HOWARD COUNTY HEALTH DEPARTMENT

RE: Percolation Test Results Application
Number: A47549
Proposed Use: Expansion of Septic System Area
to Support Proposed Addition
Property ID: 3625 Ten Oaks Road
Tax Map: 22 Parcel: 4

PERCOLATION TESTING

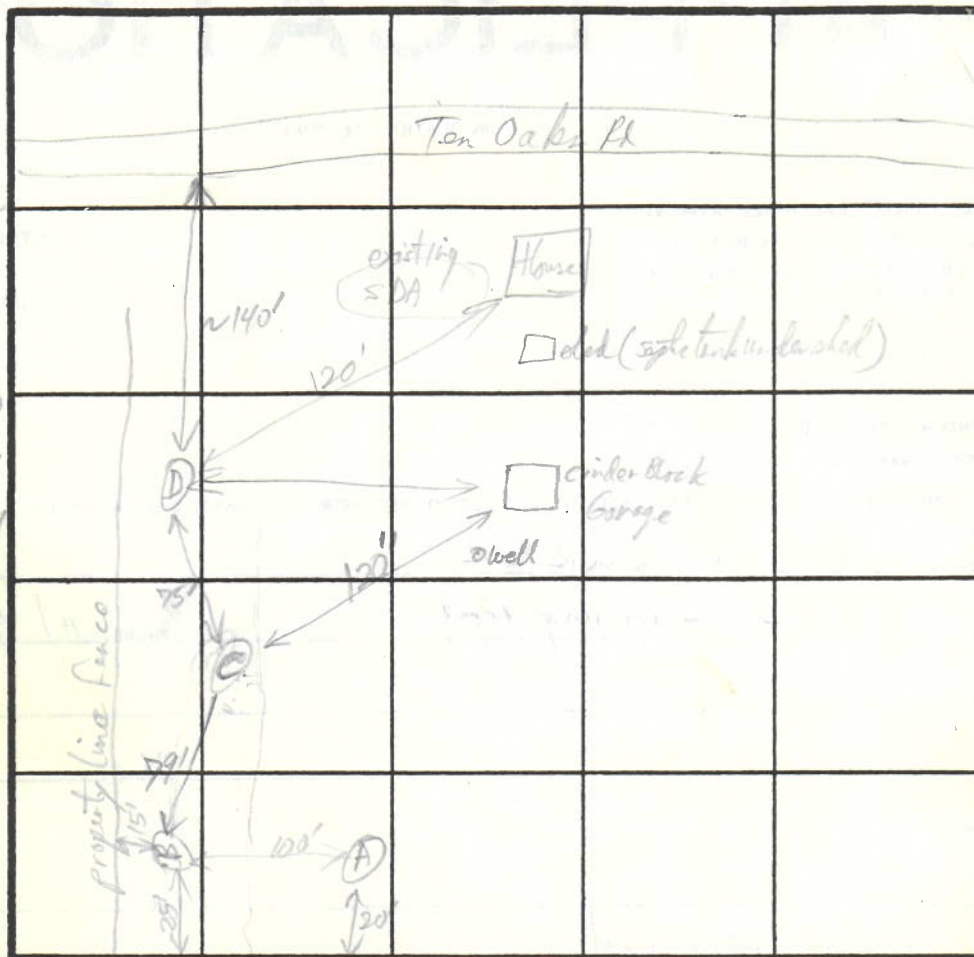
REASONS FOR REJECTION OR HOLDING Near Ivory Road (Holes A+B) can do IFA Sand Mound Tests - No In Ground

system possible because of Perched + Seasonal Water Table Problems. Elsewhere (Holes C+D)
use IFA Alternating Trenches or LPD - Trenches No Deeper than 4 1/2' because of Water Table
Design on 0.45 gpd/ft² Loading Rate or 60 min perc rate in Saprolite.
